Year 6 Monitoring Report

Hudson Property

DMS Project ID #: 95361
DMS Contract #: 004638
DWR Project #: 20140422v1
USACE Action ID# SAW-2012-01394
Beaufort County, North Carolina

RE: Hudson Monitoring Year 6 Report

**HUDSON STREAM
 RESTORATION PROJECT
 CURRENT CONDITION PLAN VIEW**
 PROJECT #95361
 FEBRUARY 21, 2022

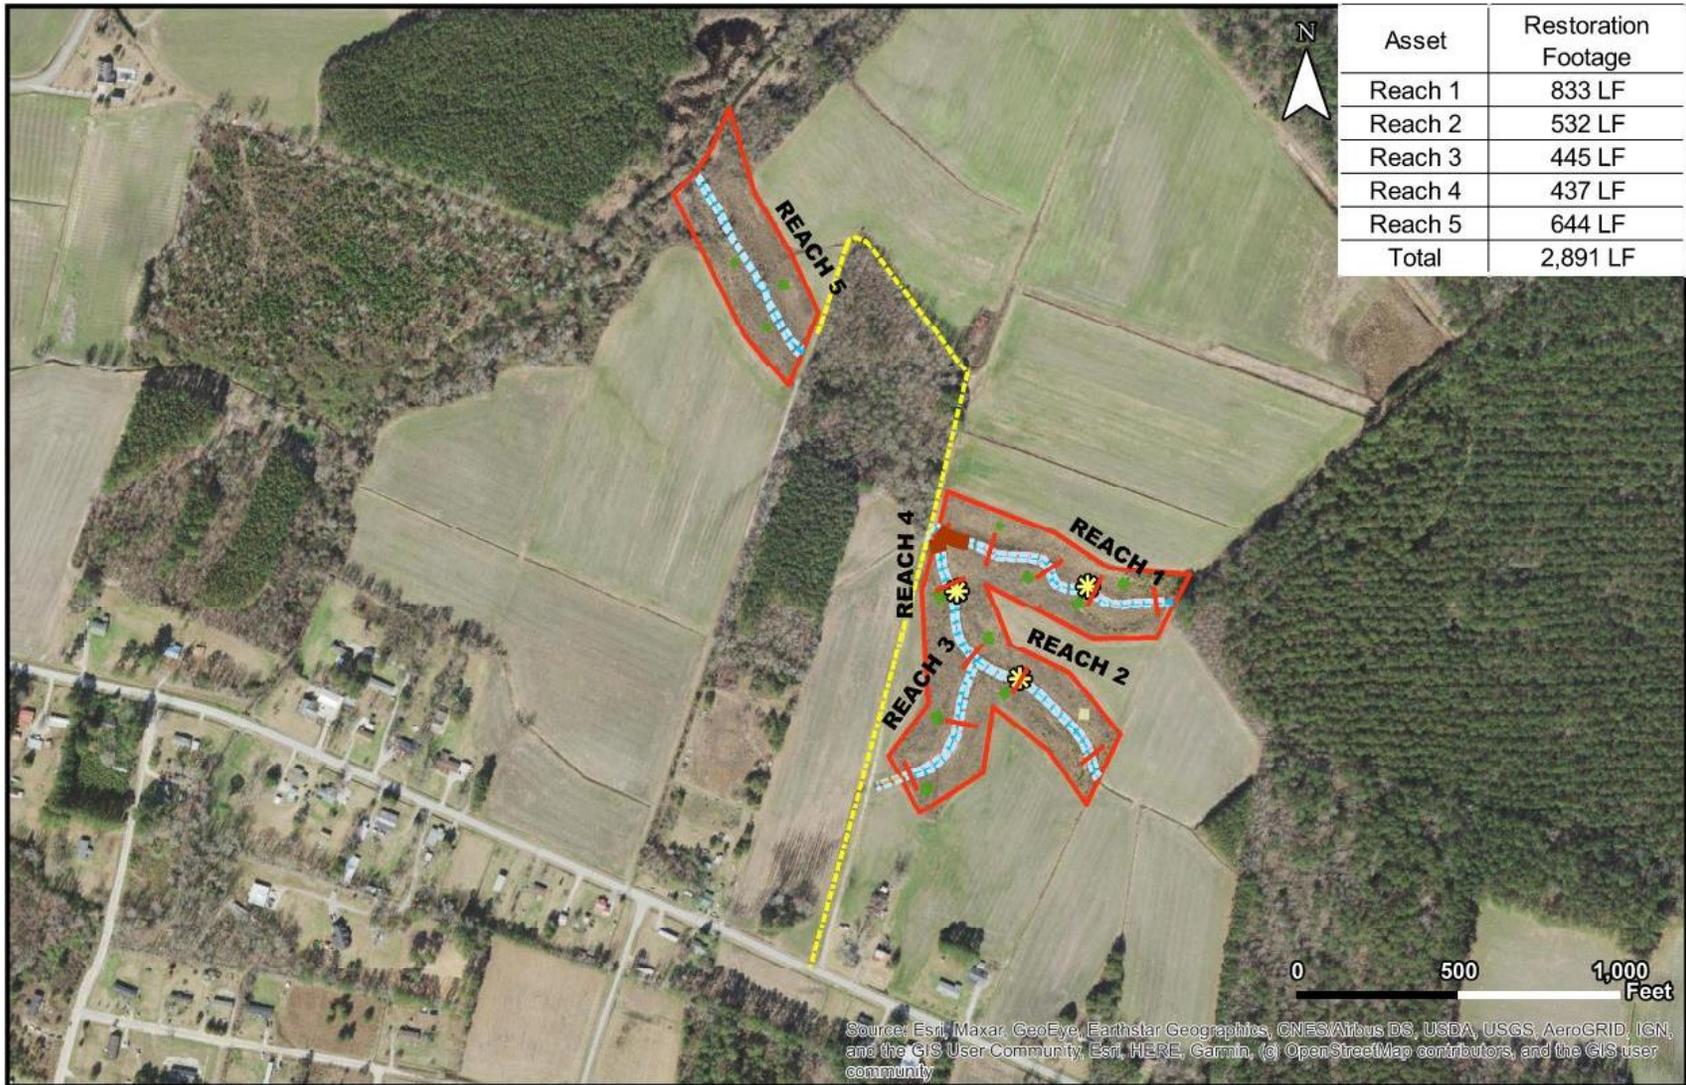
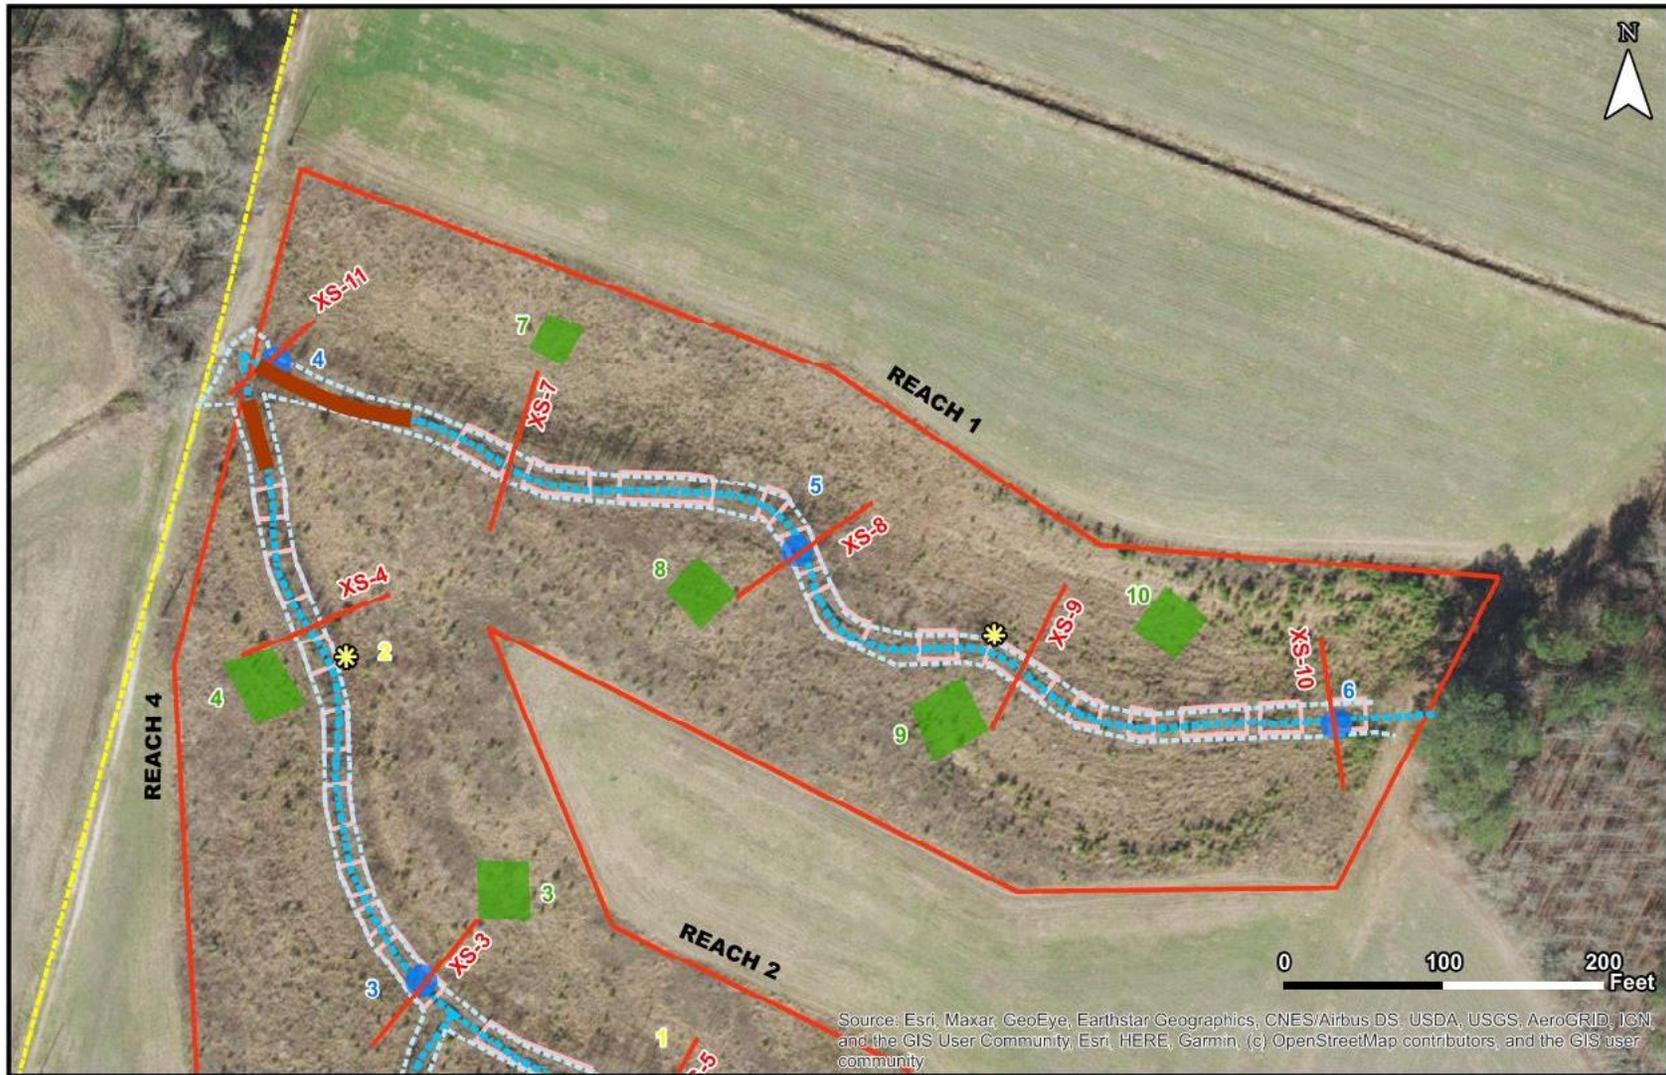
- 1. CCPVs should be georeferenced PDFs in the report. Additionally, the resolution is low on the CCPVs and some labels and features are difficult to read. Please submit higher resolution, georeferenced CCPVs exported from ArcMap (or ArcGIS Pro) in the report.*
Ecotone Response: All CCPVs have been updated with higher resolution images (pages 11-16).

Figure 4
Monitoring Well 2 – Reach 3

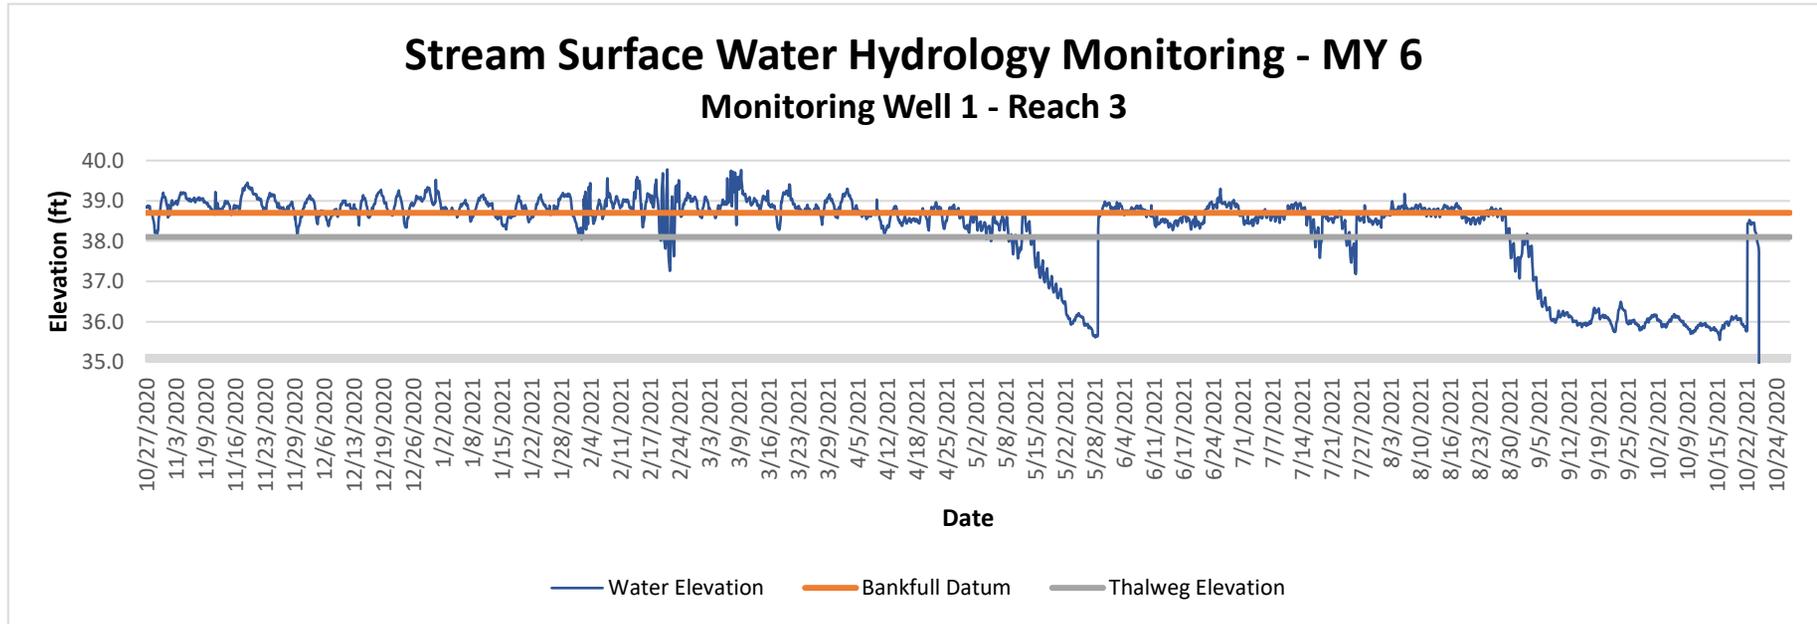
- 4. The figure for monitoring well 2 has numeric values on the x-axis instead of dates.*
Ecotone Response: Figure 4 on page 56 has been corrected to show dates on the x-axis.
